2 **Item No. 16B-RW-04**

3
4 **NCUTCD Proposal for Changes to the**
5 **Manual on Uniform Traffic Control Devices**

6
7 **TECHNICAL COMMITTEE:** Regulatory/Warning Signs Technical Committee
8 **ITEM NUMBER:** **16B-RW-04**
9 **TOPIC** **Figure 2C-3, Example of Advisory Speed Signing**
10 **for an Exit Ramp**
11 **ORIGIN OF REQUEST:** Gerard Gerhard letters of June 23, 2014 and
12 November 2, 2015
13 Task Force: Dan Paddick (Chair), Tom Heydel, Andy
14 Ramish, Erin Kissner, Herman Hill, Jason Kennedy,
15 Doug Bartlett, Bruce Ibarguen, Jim Pline, Robert Weber,
16 Paul Carlson, Rich Meredith
17 **AFFECTED SECTIONS** **Figure 2C-3, Example of Advisory Speed Signing**
18 **OF MUTCD:** **for an Exit Ramp**
19 **Section 2C.14 Advisory Exit and Ramp Speed**
20 **Signs (W13-2 and W13-3)**
21
22 **DEVELOPMENT HISTORY: Task Force: Revised 5-26-16, revised 12-28-16,**
23 **revised 1-4-17, revised 6-29-17**

Revised Figure 2C-3. Example of Advisory Speed Signing for an Exit Ramp

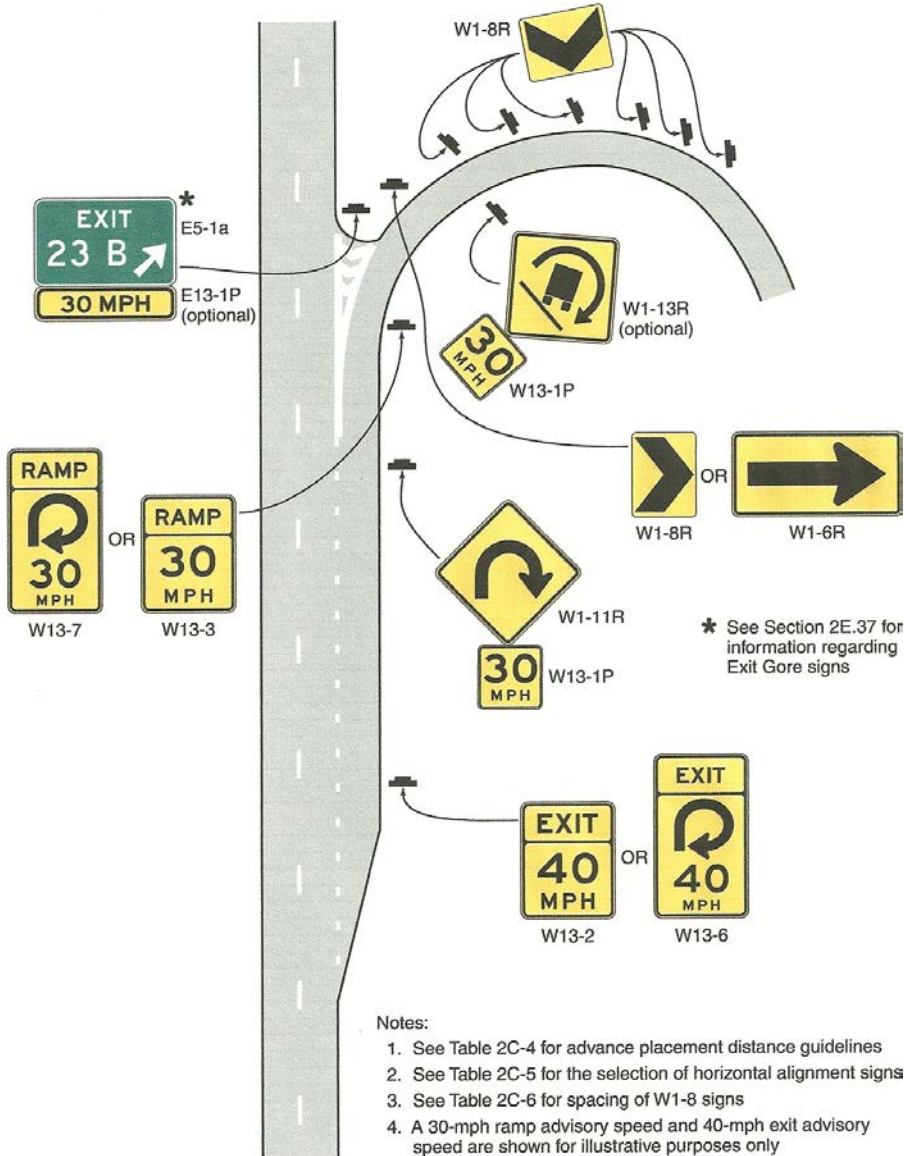
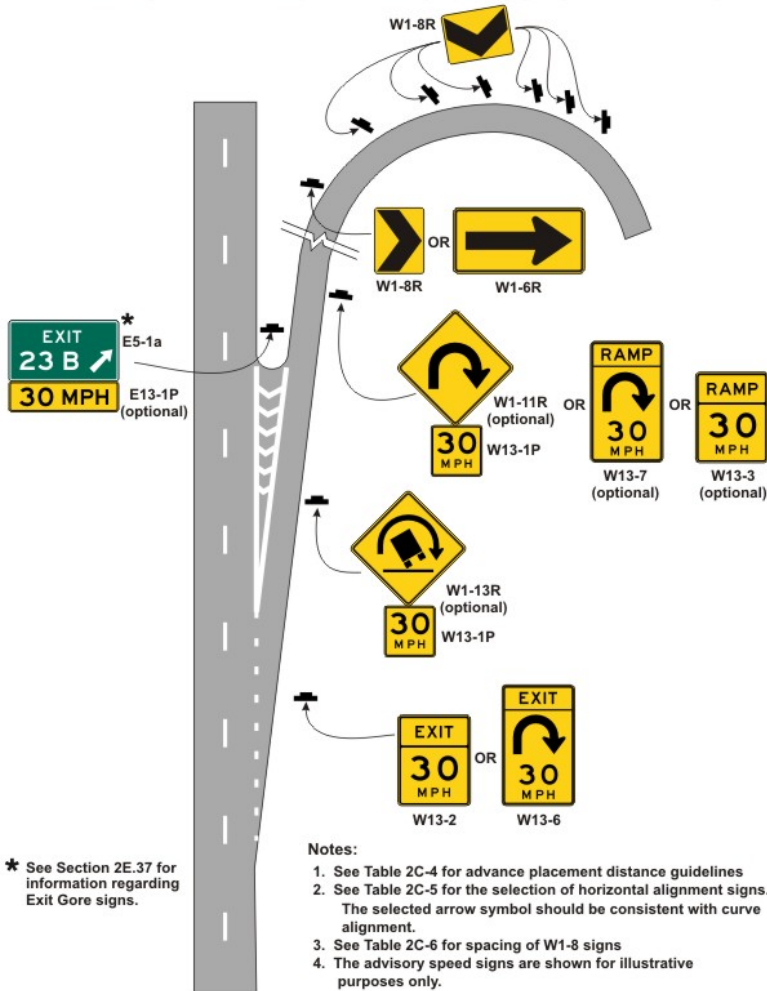
51 The “Examples” shown in Figure 2C-3 of “Advisory Speed Signing for an Exit
52 Ramp” provide “examples” of placement not just of Advisory Speed Signing,
53 but also of directional warning signs (W1-6R and W1-8R).

54 Figure 2C-3 has several problems.

55 First, at the beginning of the deceleration lane, either a W13-2 or a W13-6 is
56 shown for placement. If an exit ramp involves a curve that cannot be viewed by
57 a driver as it is approached, e.g., a curve, hairpin curve, or loop, a driver would
58 benefit from having early warning and repeated or confirming warning of such
59 condition. Accordingly, I believe the example of sign placement at the

62 Placement of warning signage regarding an exit ramp specific to a curve, hairpin
63 curve, or loop (together with an appropriate speed advisory, e.g., a W13-1P or a
64 W13-2), in addition to the signage specific to the condition (e.g., W1-11, W1-15)
65 must, at a minimum, be shown at the beginning of a deceleration lane, and
66 opposite the beginning of the gore.

67 Second, Figure 2C-3 shows as example an E13-1P as optional for display
68 together with an E5-1A. For the sake of uniformity, the E13-1P should be
69 required, rather than optional, for a ramp where advisory speed is posted.

70 Third, either a W1-8R or a W1-6R is shown as being the first warning sign in a
71 series of W1-8 signs. The W1-6 should only be used where there is an abrupt
72 change of horizontal direction, such as in a tight radius 90 degree turn. If a ramp
73 involves a curve (a curve, hairpin curve, or loop with a radius such that
74 Chevrons would be more appropriate to provide directional guidance to a driver
75 throughout a curve), the W1-6R is inappropriate. Suffice it to say, the W1-6R
76 should not be shown as preceding a series of Chevrons (W1-8), since an
77 inconsistent message is presented to a driver.

78 Fourth, the example shows as optional, placement of a W1-13R (Truck Rollover
79 Warning sign) well into a hairpin ramp. Such placement does not consider PRT.
80 If such placement is the first, or even a supplemental warning of a truck rollover
81 hazard, it would be obvious that a driver of a vehicle with a high center of
82 gravity might be in the process of rolling over when the sign comes into view.
83 There is no showing of advance placement of a Truck Rollover sign in Figure
84 2C-3. See the recommendations and reasoning regarding amendment or revision
85 of Section 2C.13, Truck Rollover Warning Sign (W1-13), set forth above.

90 Taking them in order, the first is in the second paragraph (lines 59 – 61) where Mr.
91 Garhard says that Figure 2C-3 is more than an “Example of Advisory Speed Signing for
92 an Exit Ramp”. It contains Guide signing along with W1-8R Chevrons and W1-6 One
93 Direction Large Arrow signs. We disagree with Mr. Gerhard. The E5-1 Exit sign is
94 supplemented with a E13-1P Recommended Speed Plaque. Consequently it can be
95 considered to be a type of Speed Signing. Similarly, the use and placement of the W1-
96 8R Chevrons and W1-6 One Direction Large Arrow signs are determined by speeds.
97 See Table 2C-5 and Table 2C-6. They should also be considered Speed Signing.

98 In Mr. Garhard’s first listed disagreement with this Figure (lines 63 -69), he is
99 advocating the use of W1-11 Hairpin Curve or W1-15 Loop signing at the beginning of
100 the ramp. The RWSTC disagrees. The use of these signs at this location could easily
101 cause confusion along the mainline. The purpose of using the W13-2, W13-3, W13-6
102 and W13-7 Exit and Ramp Advisory Speed Signs is to avoid confusing the through
103 traffic. The W13-6 and W13-7 signs may be adapted to curves, loops and hairpin
104 curves (Section 2C.15)

105 In Mr. Garhard’s second listed disagreement with this Figure (lines 75 -77), he is
106 advocating requiring the use of the E13-1P Recommended Speed plaque shown below
107 the E5-1 Exit sign at all locations. The RWSTC disagrees. The use of this sign is not
108 required at all locations. It should be reserved for situations where additional emphasis
109 is needed.

110 In Mr. Gerhard’s third listed disagreement with this Figure (lines 78-85), he states the
111 MUTCD should not show the One Direction Large Arrow sign (W1-6R) preceding a
112 series of Chevrons (W1-8). He believes that this usage presents an inconsistent message
113 to a driver. The RWSTC disagrees. This usage is consistent with Section 2C.12(01)
114 which states that “A One Direction Large Arrow sign may be used either as a
115 supplement or alternative to Chevron Alignment Signs in order to delineate a change in
116 horizontal alignment.” Table 2C-5 and Section 2C.14 (06) also use these signs
117 interchangeably. The MUTCD is giving the engineer the flexibility to determine the
118 best sign and sign pattern for the geometry at a specific location. This Figure is an
119 example. It should not be treated as a template for all locations.

120 In Mr. Gerhard’s fourth and final listed disagreement with this Figure (lines 86-93), he
121 questions the placement of the Truck Rollover sign (W1-13). He says that the
122 placement of this sign on this Figure in the middle of a curve does not provide the

123 necessary advance placement of the sign. If the Truck Rollover sign shown is for the
124 curve shown on the drawing, he is correct. Since a sharp curve with Chevrons and Exit
125 signing with a low recommended speed is shown, the figure is at a minimum
126 misleading. While, it is an example and not a template, it should be revised to place the
127 Truck Rollover sign before the curve.

129
130 Revise Figure 2C-3 to place the Truck Rollover sign (W1-13) in advance of the curve.
131 Place it along the parallel portion of the deceleration lane. Label the sign as “Optional”
132
133 Eliminate the Hairpin Curve sign (W1-11) along the parallel portion of the deceleration
134 lane. It conflicts with the Loop curve shown on the W13-6 and W13-7. Its use at this
135 location may cause confusion for through traffic on the mainline. Move the W1-11 sign
136 to near the end of the ramp gore. Add a W13-7 Combination Horizontal
137 Alignment/Advisory Ramp Speed sign and a W13-3 Ramp Speed sign as optional signs
138 at this location. Label all three signs as “Optional”.
139
140 Capitalize the T in Table at the beginning of paragraph 04 in Section 2C.14 Advisory
141 Exit and Ramp Speed Signs (W13-2 and W13-3)

159 **Figure 2C-3 is revised as shown below:**

Original Figure 2C-3 2009 MUTCD is shown below: Deleted and replaced with figure above.
